Partenavia P68 Series Aeroplanes

AD/P68/46

Engine Cowl

FIGURE 1 LOCATIONS TO BE INSPECTED

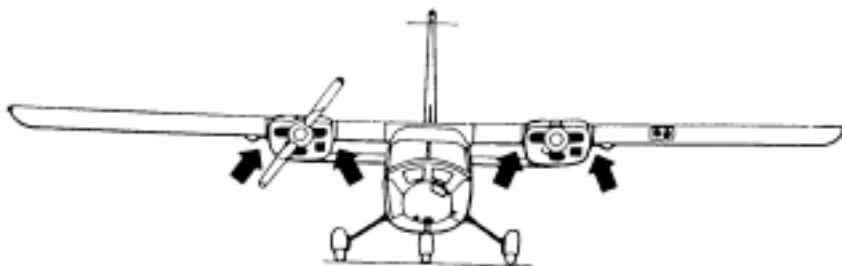
Ensure that the most forward fastener of the 'pop' fasteners attaching each engine cowl rear side fairings to the under surface of the wing is in line with the solid rivets of the lower spar cap. To assist with locating the areas, refer to the attached diagrams. If all four subject fasteners are in line with the spar cap rivets, then no further action is required.

FIGURE 2 - SIDE VIEW HIGHLIGHTING AFFECTED AREA

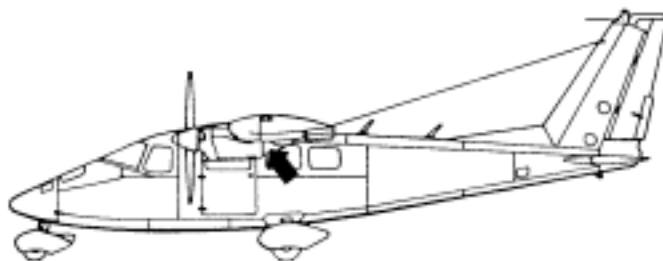
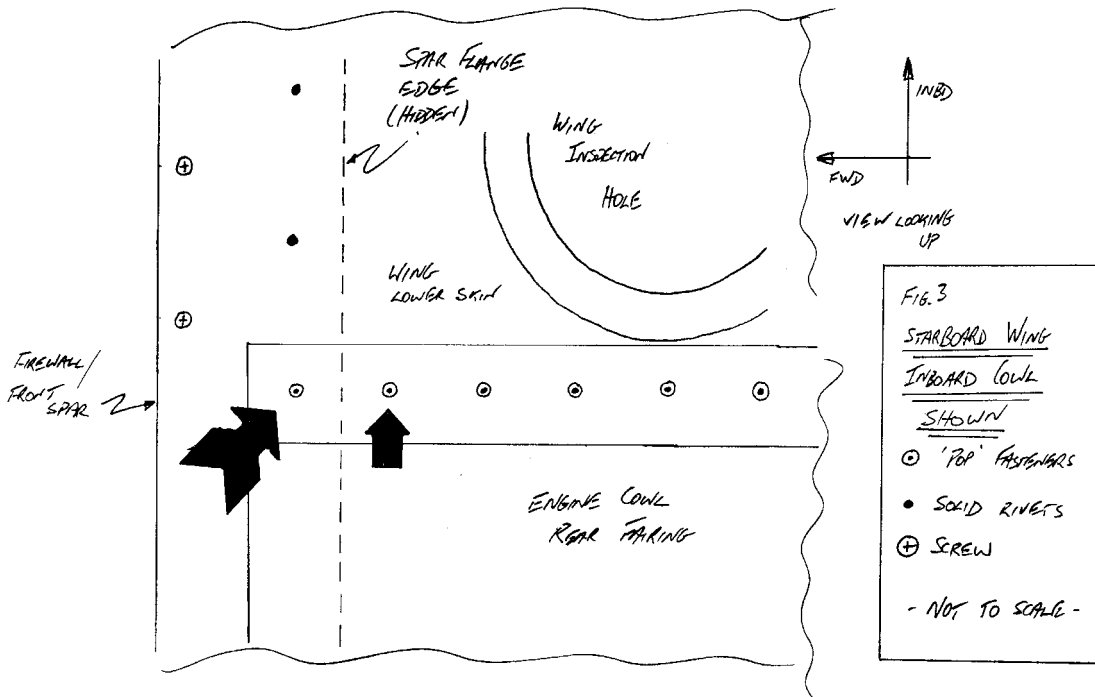
➡ CHECK LOCATION OF THIS 'POP' FASTENER RELATIVE TO LINE OF SOLID RIVETS OF LOWER SPAR CAP.
 NOTE: CORRECT ALIGNMENT SHOWN

➡ CHECK LOCATION OF THIS 'POP' FASTENER RELATIVE TO SPAR FLANGE IF FORWARD 'POP' FASTENER MISALIGNED.

If a fastener is not in line with the spar cap rivets, before further flight, the location of the forward fastener, its orientation and direction relative to the all spar cap elements is to be determined. The second most forward fastener is also to be inspected in a similar manner.

In all cases of misaligned fasteners, a defect report is to be made to CASA and an assessment by a CAR 35 authorised person is required prior to further flight.
